Bid Clarification #2 – 09-12-18

Silvercrest at Meadowbrook

RFI LOG & RECAP

E1.0

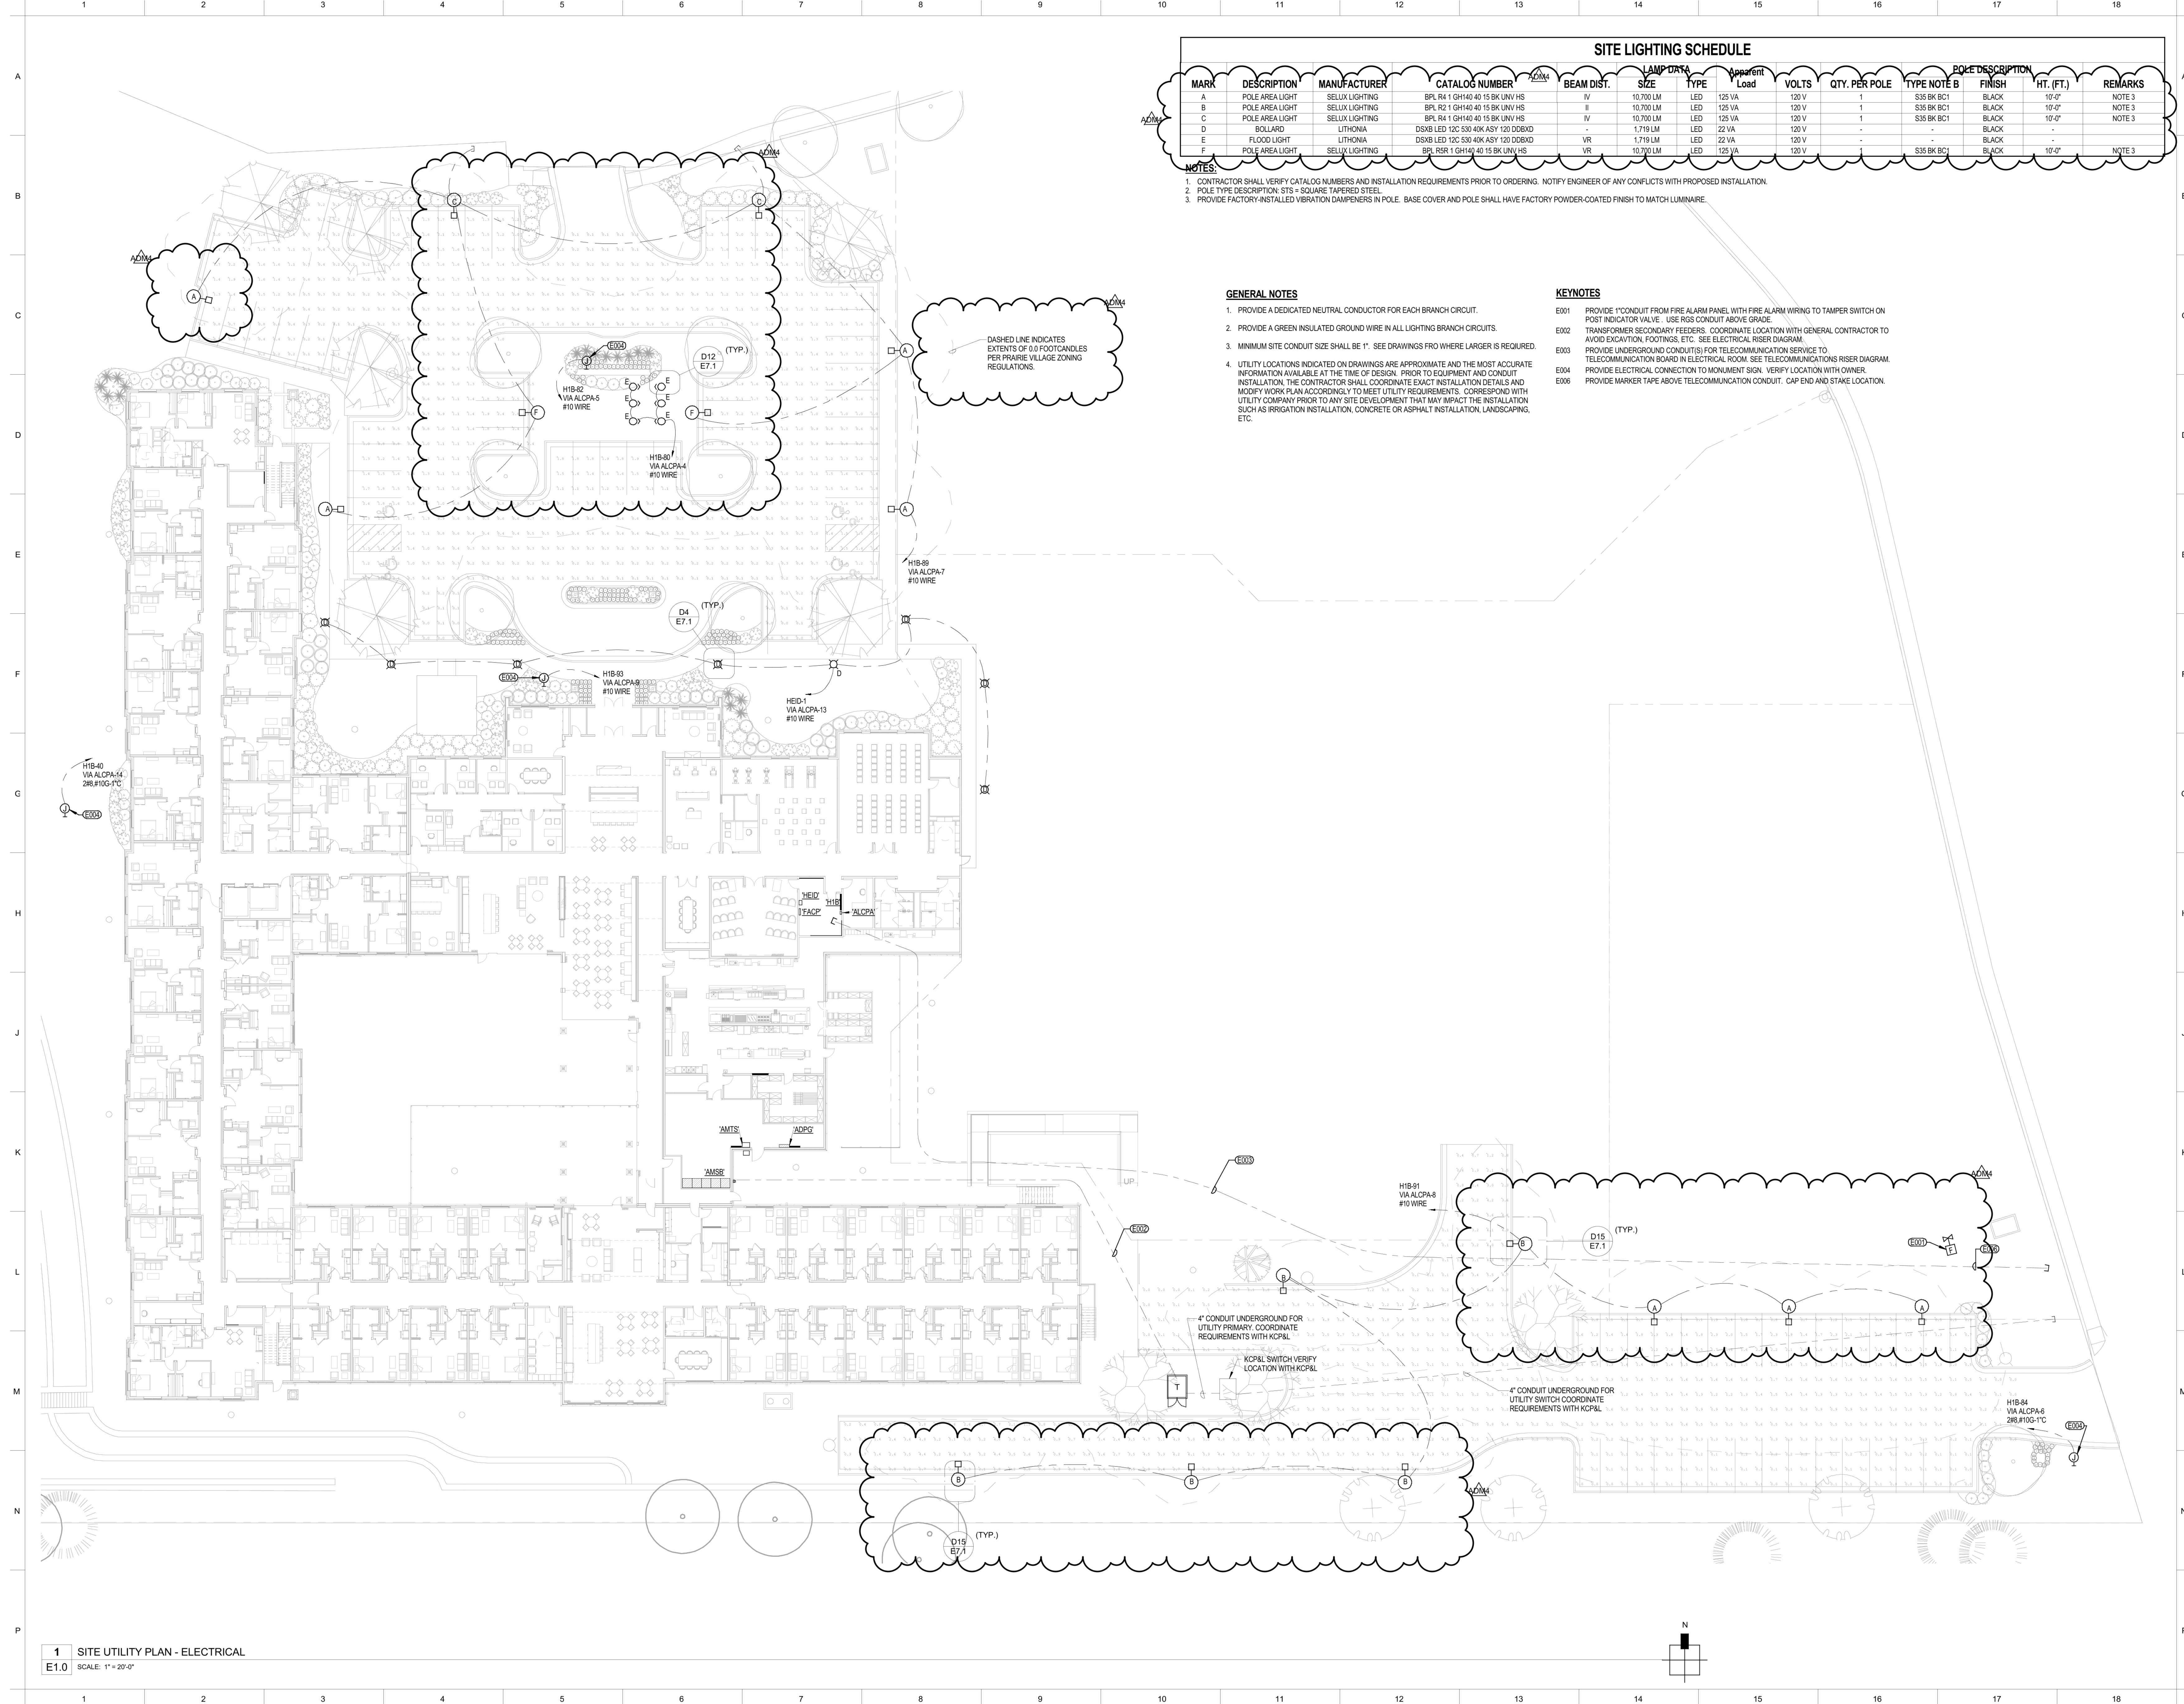
1. Referce the lighting schedule on sheet E1.0 for type E, which appears to be a parking lot pole light on the plans. However, near grid D6, there are also type E lights referencing D12/E7.1.

Please provide clarification for the lights shown in detail D12/E7.1.

There was an error on sheet E1.0, which was part of Addendum #4 for Silvercrest at Meadowbrook, Phase 1. Please see the attached for the revised Addendum #4 and distribute accordingly.

See below and attached. Sheet E1.0 has been revised.

Yes this revised addendum provides the clarification for RFI#13.
